PRELIMINARY DRAINAGE PLAN

CREEKSIDE SOUTH AT LORSON RANCH

PUD SP-20-001

Project No. 100.051

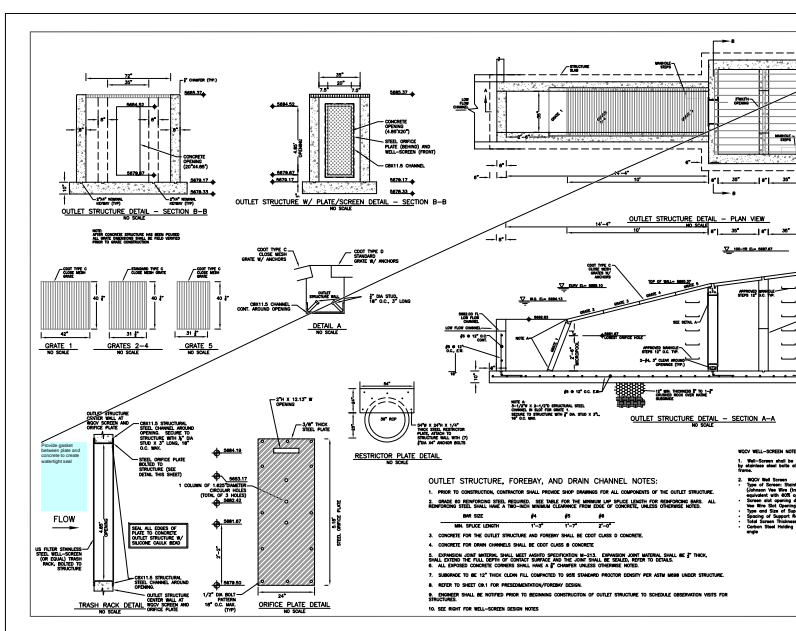
Label elevations. Are you going to specify method of construction (drilling/grinding vs torch?) or required finish (not rough)?

ELEVATIONS LABELED. DRILL/CUT HOLES. SMOOTH EDGES.

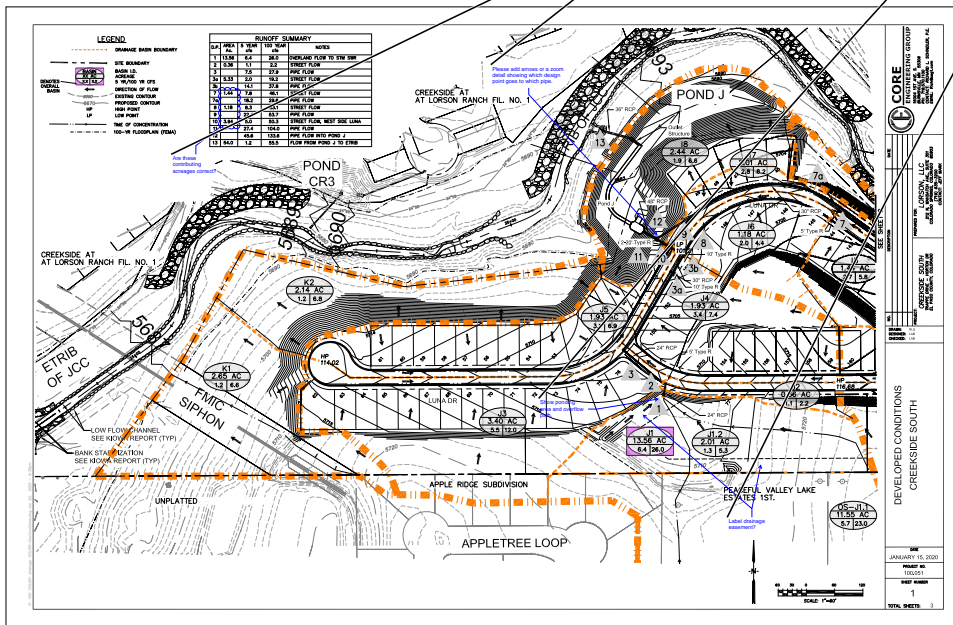
Show ponding area and overflow path.

Author: RSchindler Subject: Sticky Note Date: 5/11/2020 11:47:41 AM
POND ELEV. ADDED AND ARROW
